South Texas Project Electric Generating Station 4000 Avenue F – Suite A Bay City, Texas 77414

February 10, 2010
U7-C-STP-NRC-100036

South Texas Project
Units 3 and 4
Docket Nos. 52-012 and 52-013
Response to Request for Additional Information

Attached are the responses to the NRC staff questions included in Request for Additional Information (RAI) letter numbers 299 and 302 related to Combined License Application (COLA) Part 2, Tier 2, Sections 3.7.1, 3.7.2 and 3.8.4.

Figure 03.08.04-17f: Comparison of DCD and STP 3 & 4 lateral soil pressure H' for design of RB Walls

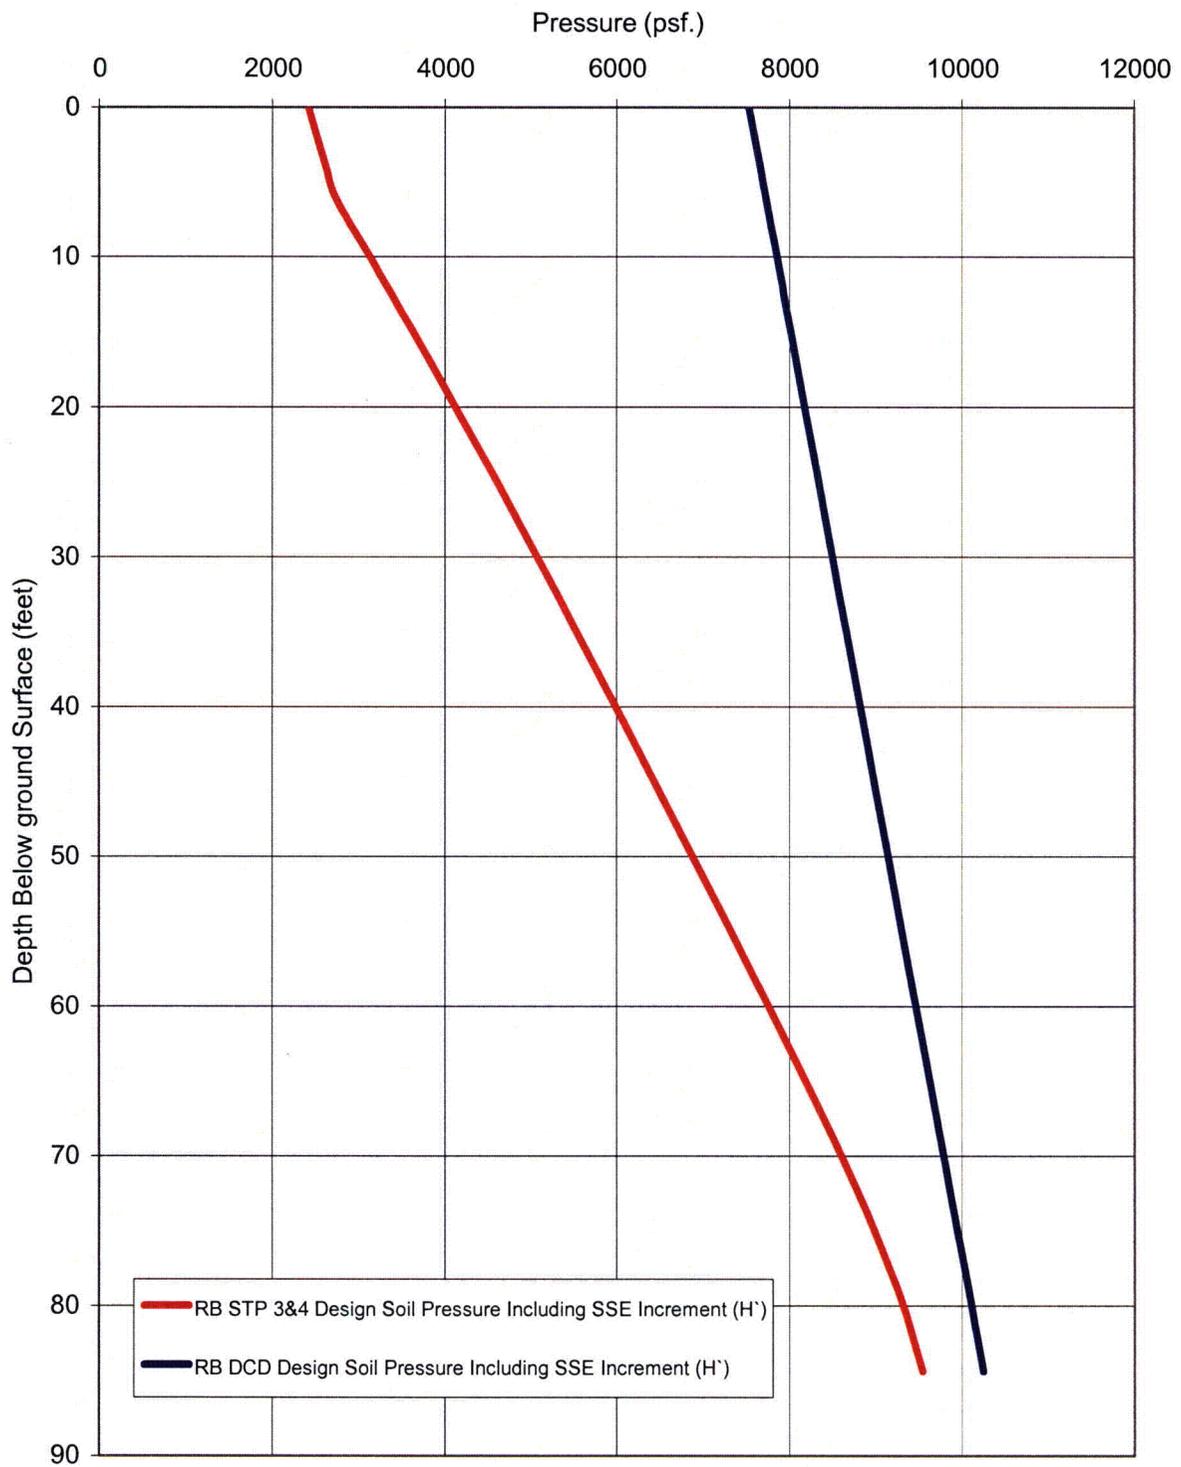
- b) Per Sections 3H.1.4.3.1.8 and 3H.1.5.5.3.1 of the ABWR DCD, Tier 2, the lateral soil pressures used for the design of Reactor Building (RB) walls are provided in Figure 3H.1-11 of DCD Tier 2. Also, per Section 3H.2.4.3.1.4 of DCD Tier 2, the lateral soil pressures used for the design of Control Building (CB) walls are provided in Figure 3H.2-14 of DCD Tier 2.

Figures 03.08.04-17a through 03.08.04-17l on the following pages provide the following:
